SERVICE BULLETIN

Number 20180514

Title: Replacing OEM contactor on AFD420 and AFD930

Models effected: AFD420 and AFD930

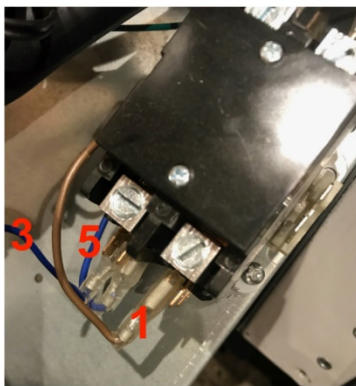
The OEM contactor is a double throw. In this instance it is switching both the Active and the Neutral.

1(Brown) is the main Active at the contactor's switch exiting at 2(Black) the active going to the compressor.

3(Blue) is the main Neutral at the contactor's switch exiting at 4(White) the Neutral going to the compressor.

5(Blue) forms a loop from 3(Blue) to the Neutral of the contactor's coil.

6(Brown) Is the active to the Connctators coil. This active is fed from the Dixcell controller.

Below is The Single Throw relay (contactor) that we use to replace the OEM contactor.

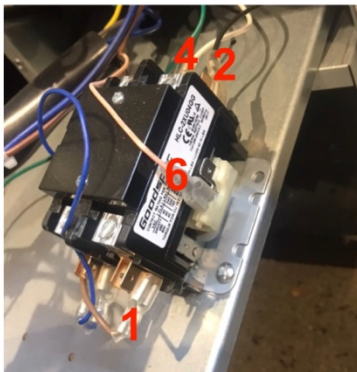
Reason: The EOM contactor is not available in Australia. The Double throw contactor used can be replaced by a 30amp relay that is available from most refrigeration wholesalers. The one used in the example below can be purchased from Actrol

From the numbering above (in RED) fit to the numbering on the replacment relay (in BLACK)

1 (Brown) Main active	fitted to	1
2 (Black) compressor active	fitted to	4
5 (Blue) Neutral to coil	fitted to	5
6 (Brown) Active to coil	fitted to	6

Note the nuetral is not switched 3 4 and 5 are joined together
